Project	IEEE 802.16 Broadband Wireless Access Working Group < http://ieee802.org/16 >	
Title	Slave Hierarchy for Better Usage of Regions not Interfered by the Master Subframe	
Date Submitted	2006-11-08	
Source(s)	Avi Freedman Hexagon	Voice: +972-3-9224420 Fax: +972-3-9223596 Email: avif@hexagonltd.com
Re:	Letter Ballot # 24	
Abstract	Suggestion for improvement of usage of overlapping regions in the ASFA scheme, using slave hierarchy	
Purpose	Improving usage of overlapping regions by introducing priority among slaves in the ASFA algorithm. This priority will allow serving the regions where there is slave coverage overlap, without interference to the master.	
Notice	This document has been prepared to assist IEEE 802.16. It is offered as a basis for discussion and is not binding on the contributing individual(s) or organization(s). The material in this document is subject to change in form and content after further study. The contributor(s) reserve(s) the right to add, amend or withdraw material contained herein.

Slave Hierarchy for Better Usage of Regions not Interfered by the Master Subframe

Fig. h41a: Priority Order for a 3 system community

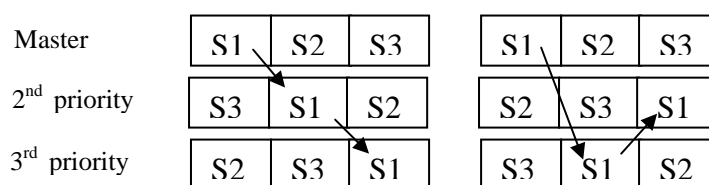
Add the following text to section 15.4.2.1.2: (p. 89 1. 29 of [1]):

In order to enable service to regions in which two slave systems overlap, a hierarchy structure shall be applied among the slaves, as follows:

- In one MAC frame, in case of type 1 structure, or in the first (N+1) MAC frames, in case of type 2 structure, the system "rank" will be demoted by one in each subframe, namely, the master system of the i^{th} sub frame will in subsequent frames still have priority over all the systems that were not given the mater status till that frame.
- In the second MAC frame, in case of type 1 structure, or for the MAC frames from the $(N+2)^{\text{th}}$ till the $2(N+1)^{\text{th}}$, in case of type 2 structure, system "rank" will be promoted in each subframe, namely, the master system of the i^{th} sub frame will have in subsequent subframes priority only over systems that were given the master status after it.

Where the "rank" of the system relates to the order of priority it has over other systems.

Figure h41a shows the priority order for 3 systems in different sub frame structures. The common parts and TX/RX boundaries are omitted. The arrows show the priority demotion and promotion for system S1.
